Ballincor Wind Farm

Response to Submissions Report

Document Control Sheet	
Document Reference	Ballincor Wind Farm Response to Submissions Report
Client:	RWE
Project Reference	11333

Figure 2-1 Summary Section NE from T8

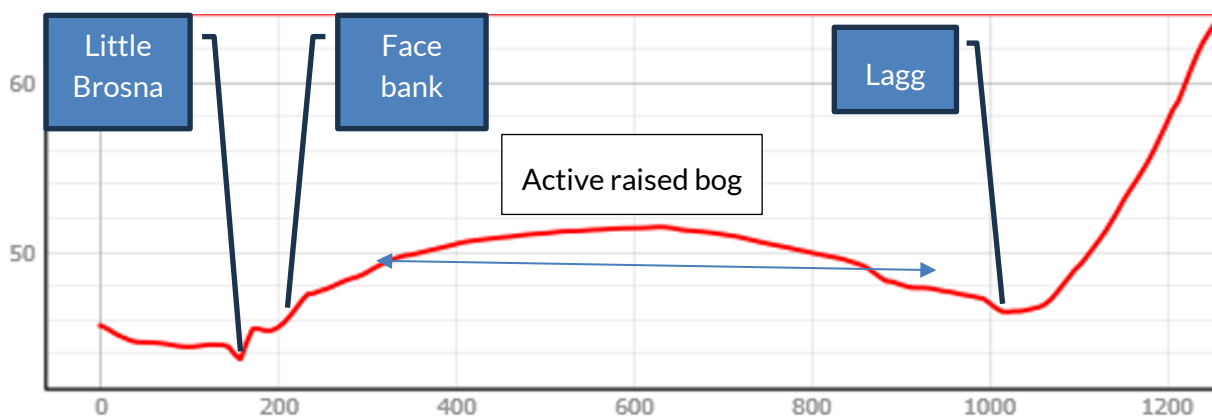
The DoHLGH questions the conclusion presented within the NIS and the EIAR that no hydrogeological connection exists between the Proposed Project and Sharavogue Bog SAC. Specifically, the DoHLGH notes that the assessment appears to rely primarily on a conceptual hydrogeological model and that it is unclear whether any site-specific groundwater monitoring was undertaken to verify this conclusion. Given the sensitivity of the qualifying habitats within the SAC, the DoHLGH considers that additional evidence is required to demonstrate, beyond reasonable scientific doubt, that no hydrological pathway exists that could adversely affect the conservation objectives of the SAC.

Sharavogue Bog SAC is located to the east of the River Brosna. The area is underlain by deep low permeability soils. Peatlands on the proposed wind farm site are not hydrological/hydrogeological connected to the raised bogs habitats to the east of the Little Brosna River. A summary of the distances to the Sharavogue Bog SAC and associated habitats are included in Table 2-1 below. The extent of the active raised bog habitats within the Sharavogue Bog SAC are controlled by the boundary conditions, i.e. lagg zone, former railway and drainage to the east and by the drainage (within the SAC) and face banks to the west. The lagg zone corresponds to a thin strip of fen peat located between the Raised bog and Basic Mineral soils/tills derived from limestones on Figure 8-2 and Figure 8-4 of the EIAR. Based on the details topography information, this is located at the base of steep hill in the townland of Rathbeg.

Figure 2-2 Landscape Classification

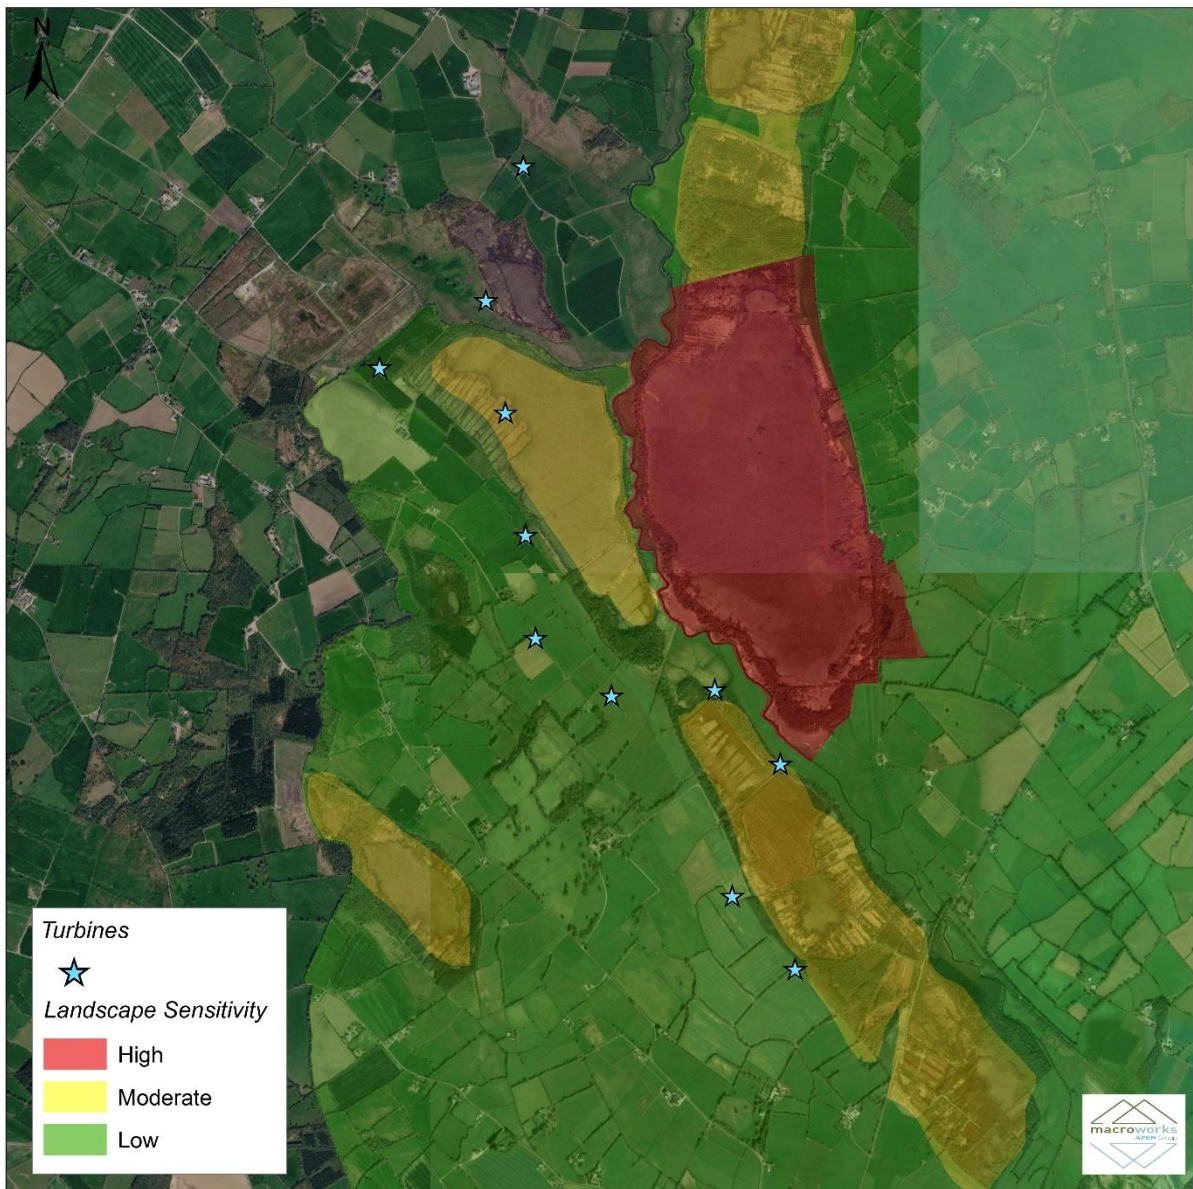
The Planning Authority considers that the proposed wind turbines will be significant and dominant features in the landscape. The Planning Authority, in particular, having regard to the proximity, orientation and exposure of a significant number of dwellings in the area to the proposed turbines, strongly disagrees with the conclusions contained in Section

None of the proposed turbines is contained within the 'High' sensitivity landscape classification area. One turbine is contained in a 'Moderate' sensitivity area, but within an area of cutaway peatland and the remaining turbines (within County Offaly) are all contained in a 'Low' landscape sensitivity zoning. Consequently, the 'Medium-low' landscape sensitivity assessment within the project LVIA is considered to be a reasonable one. Figure 2-2 below is a clearer version of the landscape sensitivity as presented in Figure 12.3 of the EIAR.

Notwithstanding, the nuances of mapped boundaries between landscape sensitivity zonings, the landscape should not be read in such a compartmentalised manner and boundaries between landscape classification units are seldom as abrupt on the ground as they appear in CDP maps. This landscape reads as a flat to gently undulating combination of productive agricultural land, cutaway peatland and peatland fringe scrub and commercial forestry. The Offaly CDP has taken the somewhat unique approach of classifying peatland areas and cutaway peatland areas as being of High or Moderate landscape sensitivity and this would not necessarily conform with a more universal approach to classifying landscape sensitivity. Whilst the CDP classifications are an important consideration in the LVIA, they are not definitive and in accordance with relevant Guidance (GLVIA3) the landscape specialist should arrive at their own conclusions regarding landscape sensitivity that are specific to the project scale.
